**SUBJECT: Draft Final Construction Completion Report for the Ash Landfill Operable Unit;  
Seneca Army Depot Activity, Contract FA8903-04-D-8675, Delivery Order 0012,  
CDRL A001C**

**SUBJECT: Draft Final Construction Completion Report for the Ash Landfill Operable Unit;  
Seneca Army Depot Activity; EPA Site ID# NY0213820830; NY Site ID# 8-50-006**

**DRAFT FINAL  
CONSTRUCTION COMPLETION REPORT  
FOR THE ASH LANDFILL OPERABLE UNIT  
SENECA ARMY DEPOT ACTIVITY**

## **Army's Response to Comments from the New York State Department of Environmental Conservation**

D-1  
 SOIL REMEDIATION:  
 AS BUILT DRAWING

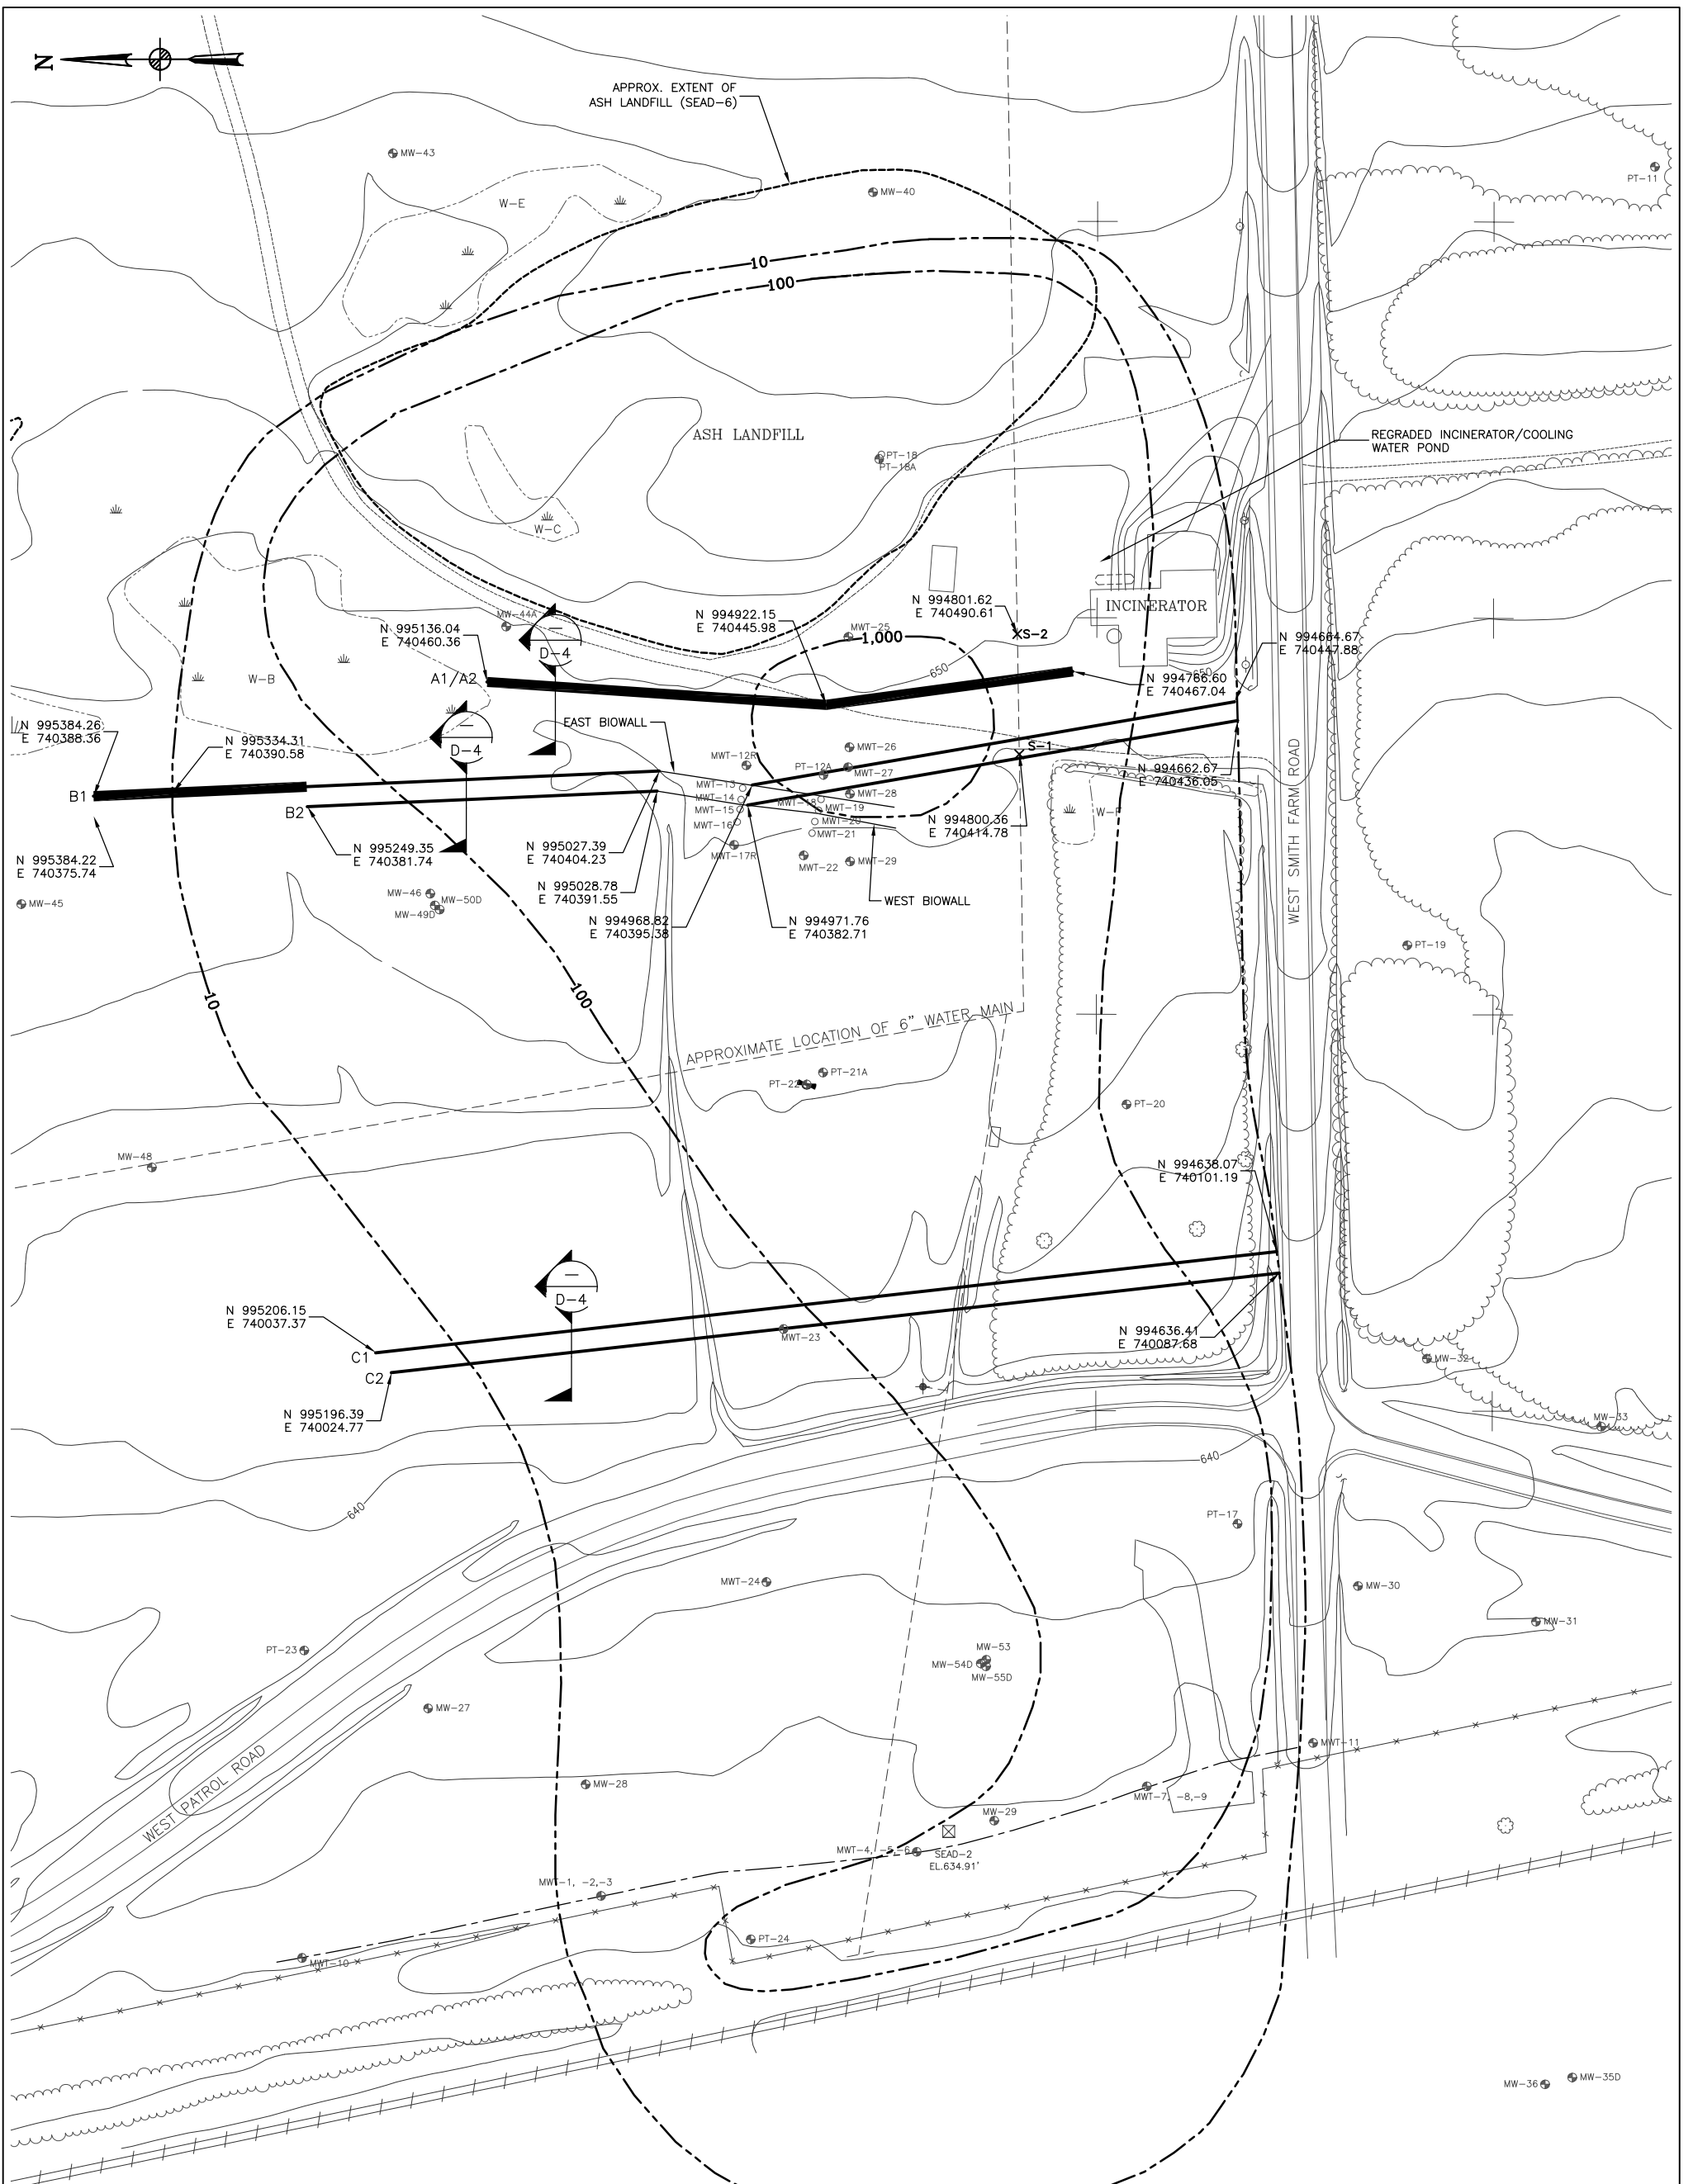
**Comment 2: Section 2.1: Site Preparation Activities, Page 2-1.** The second paragraph describes the utility clearance conducted and indicates that an abandoned water line was cut during trench installation. The cuts were reportedly surveyed and marked on Drawing D-2. Drawing D-2 does show an approximate location for the cuts, but survey information is not provided. Please revise drawing D-2 to provide the survey information for the cut in the abandoned water line.

**Response 2:** Drawing D-2 has been revised and the survey coordinates are posted on the drawing.
